**OHIO TURNPIKE AND  
INFRASTRUCTURE COMMISSION**

**ADDENDUM NO. 1**

**PROJECT NO. 59-16-01**

**REPAIRS AND RESURFACING  
EASTBOUND AND WESTBOUND ROADWAYS  
MILEPOST 38.90 TO MILEPOST 43.30  
FULTON COUNTY, OHIO**

TYPICAL SECTION - SHOULDER REPLACEMENT

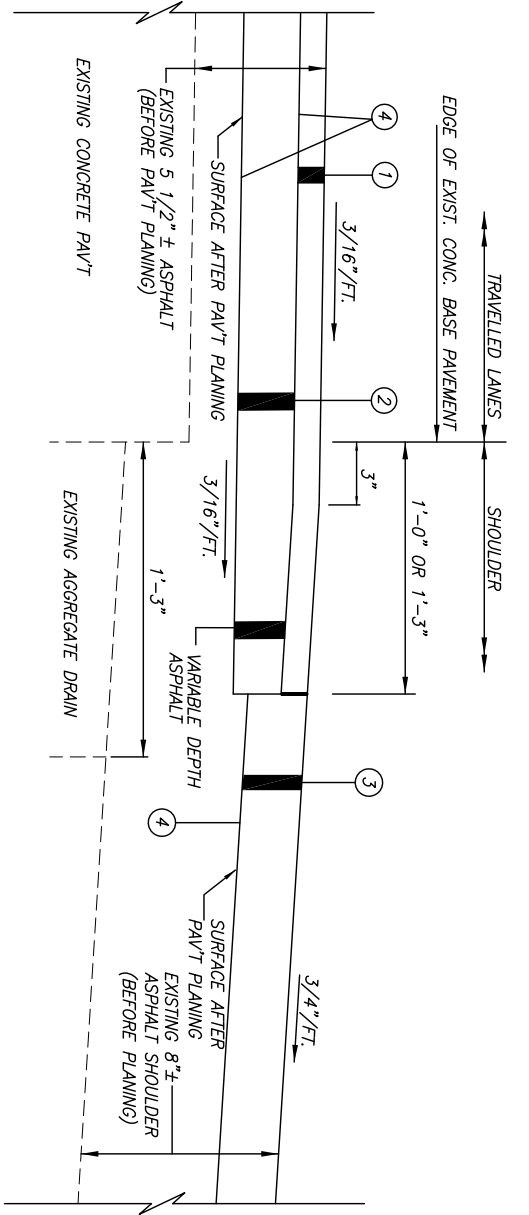
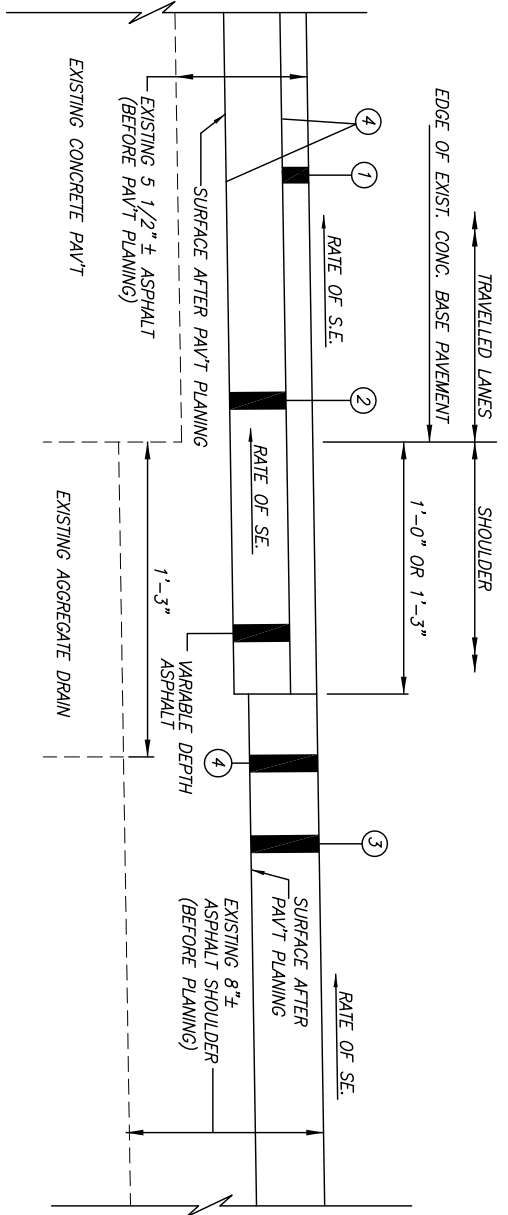
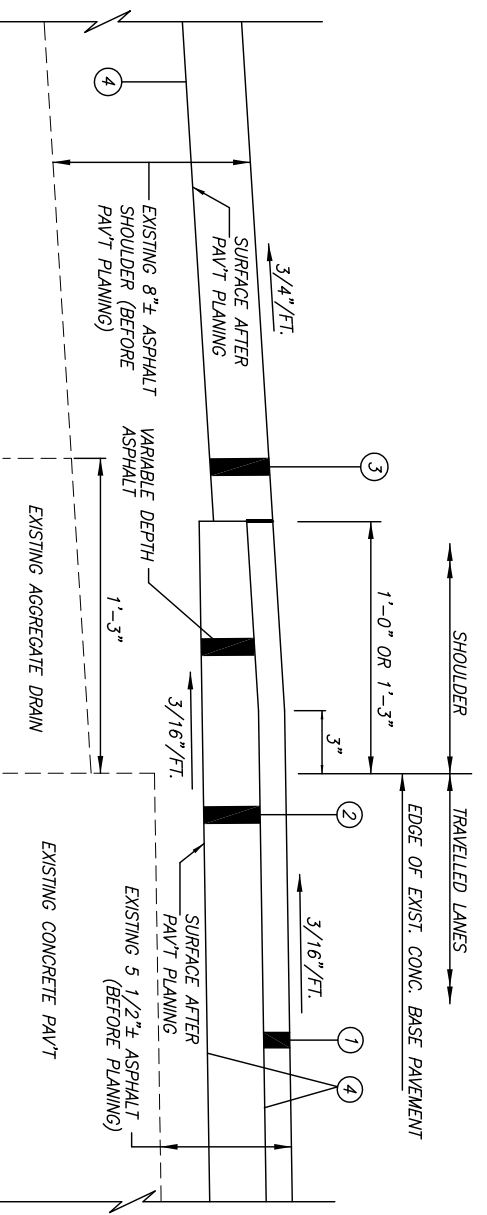
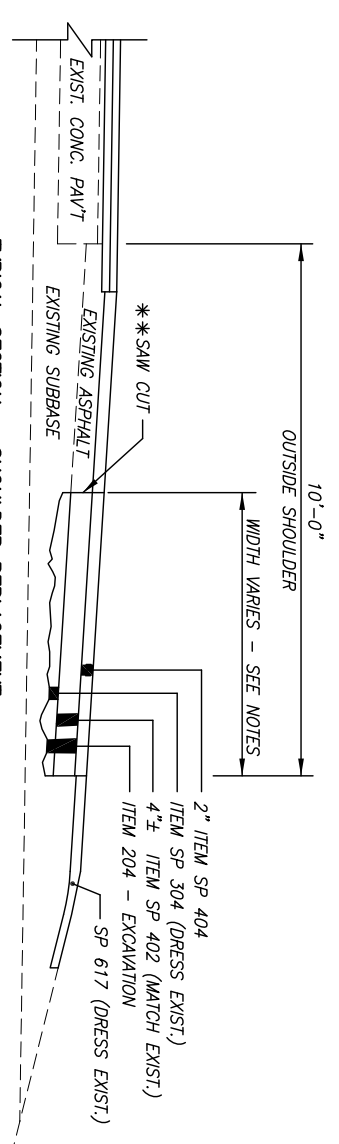
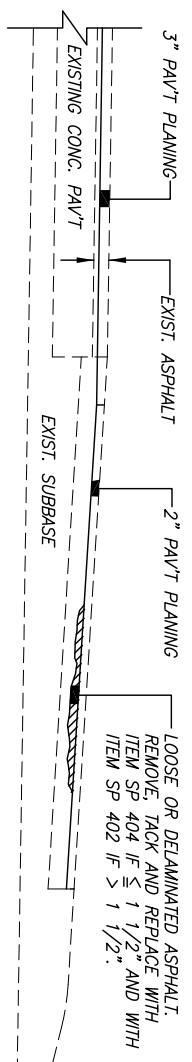
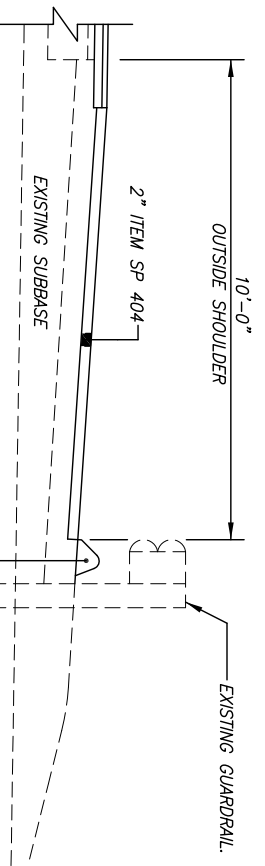
- Q#2** On sheet 5/11, the details for shoulder replacement and shoulder surface repairs both call for an contingent item of SP 402 Asphalt concrete Intermediate course PG 64-22. There is no bid item for Asphalt concrete Intermediate course PG 64-22 listed in the bid items?

- A#2* This Addendum modifies Plan Sheet 5 of 11 to revise TYPICAL SECTION - SHOULDER SURFACE REPAIR detail description for ITEM SP 402 as follows: ASPHALT CONCRETE INTERMEDIATE COURSE, ~~USING CRUSHED STONE~~, PG 64-22. The revised plan sheet is included with this Addendum No. 1. For the addition of the Bid Items, see the response to Q#1.

**ITEM SPECIAL - LONGITUDINAL JOINT STABILIZER, POLYMER EMULSION**

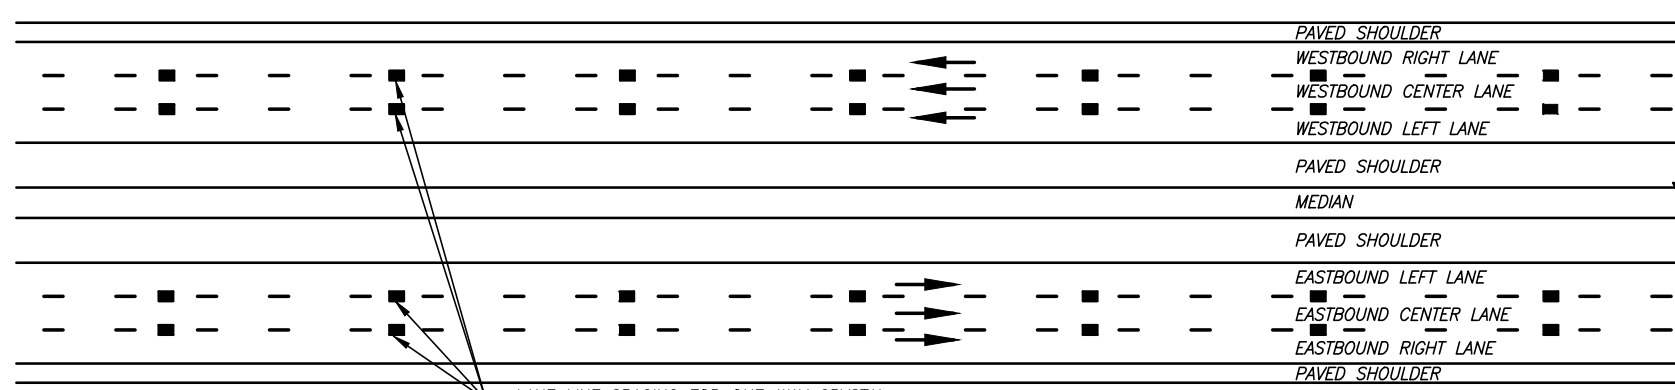
Plan Sheet 11 of 11 is modified to insert a Note for **ITEM SPECIAL - LONGITUDINAL JOINT STABILIZER, POLYMER EMULSION.**

THIS ITEM SHALL CONSIST OF SUPPLYING AND PLACING APPROXIMATELY 1,200 GALLON OF A POLYMERIZED EMULSION. THE POLYMERIZED EMULSION SHALL BE JOINTBOND AS MANUFACTURED BY D & D EMULSIONS OR APPROVED EQUAL BY THE CHIEF ENGINEER.

THE POLYMERIZED EMULSION SHALL BE APPLIED 36" WIDE AND CENTERED ON THE LONGITUDINAL JOINT BETWEEN THE RIGHT AND LEFT LANE (ORIGINAL CROWN LINE). THE POLYMERIZED EMULSION SHALL BE PLACED AFTER THE SP 404 SURFACE COURSE IS COMPLETE AND IN PLACE (BOTH LANES PAVED) AND SHALL BE APPLIED TO THE LONGITUDINAL JOINT IN ACCORDANCE WITH THE MANUFACTURERS RECOMMENDATIONS AND SPECIFICATIONS. THE APPROXIMATE APPLICATION RATE OF 0.08 GALLON/SQ.YD. SHALL BE USED UNLESS MODIFIED BY THE MANUFACTURER.

PAYMENT FOR THIS ITEM SHALL BE AT THE CONTRACT UNIT PRICE PER SQUARE YARD FURNISHED, INSTALLED AND ACCEPTED BY THE CHIEF ENGINEER, AND SHALL INCLUDE ALL LABOR, EQUIPMENT AND MATERIALS, TRAFFIC CONTROL, AND INCIDENTALS NECESSARY TO COMPLETE THIS ITEM.
